March 2, 2021

**Re: WDNR Water Resources Application for Project Permits – Data Request Response**

# February 1, 2021 WDNR L5WSRP Data Request Response

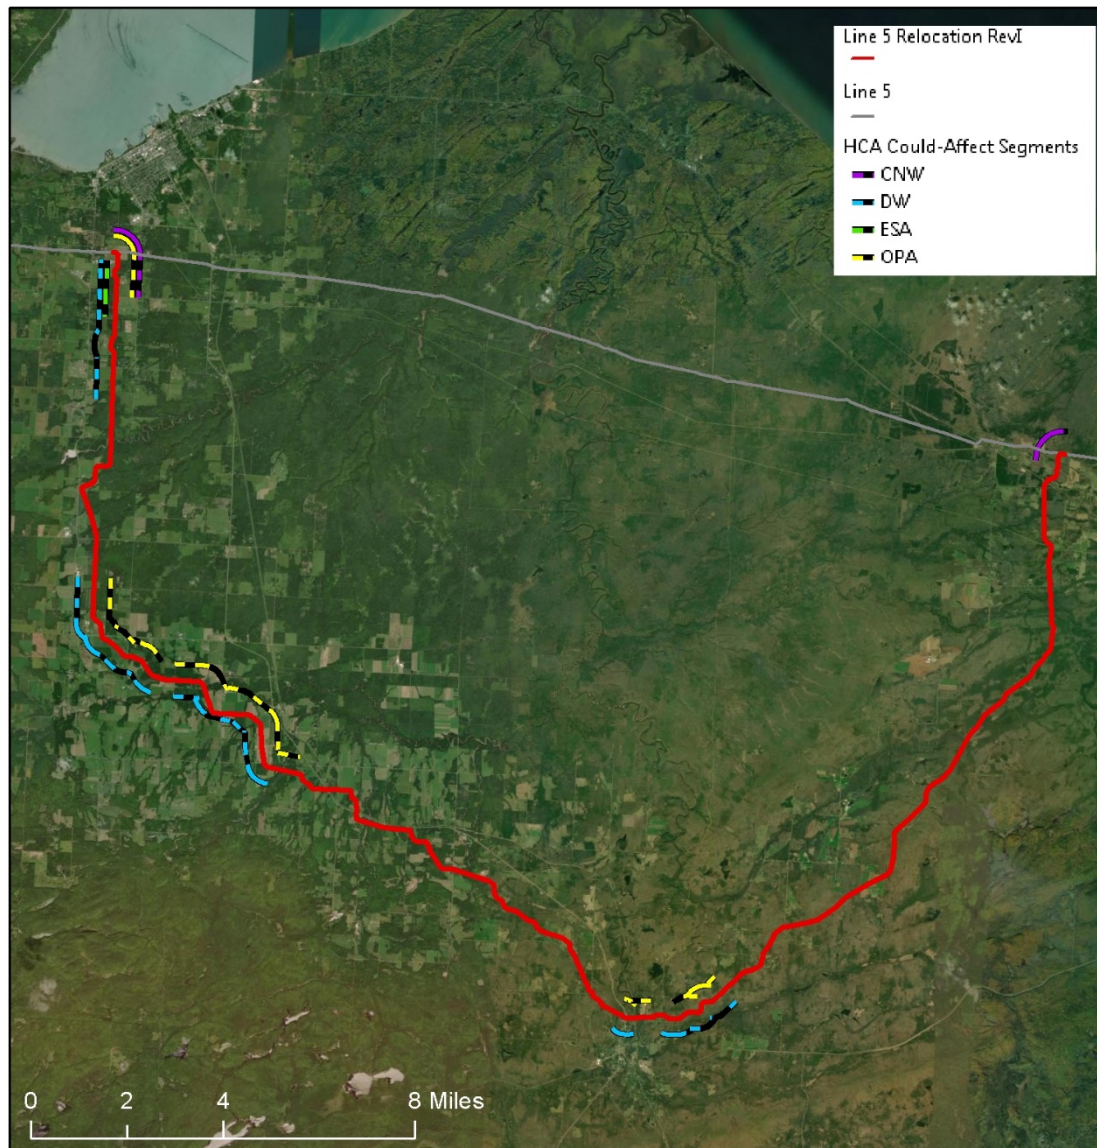
- vii. state is an Emergency Flow Restriction Device (EFRD) analysis was conducted on the reroute.
  - viii. indicate the location on a map where the pipeline could leak into HCAs and/or USAs with the maximum drain-down volume.

A thorough IVP analysis has been conducted to place EFRDs (*i.e.*, mainline block valves) on the re-route. Upon collecting the information listed in section 4b(iii), volume-out is calculated for the re-route following the methodology explained in section 4b(i). Using the volume profile, the valve placement analysis is consequently performed with the purpose of reducing the impacts of a release event to the HCAs, watercourse crossings, wetlands, and other sensitive areas near the pipeline. The valve placement analysis is performed on each segment of the line on an iterative basis until the lowest reasonably practicable release volume between valves is achieved along the pipeline.

Upon completion of IVP analysis, Enbridge conducts a field verification of recommended valve locations. Field verification will evaluate the impact of construction to the environment, including the following factors: valve site access, constructability, power, and land availability. Final valve locations were adjusted due to constructability issues and environmental impacts identified during field verification.
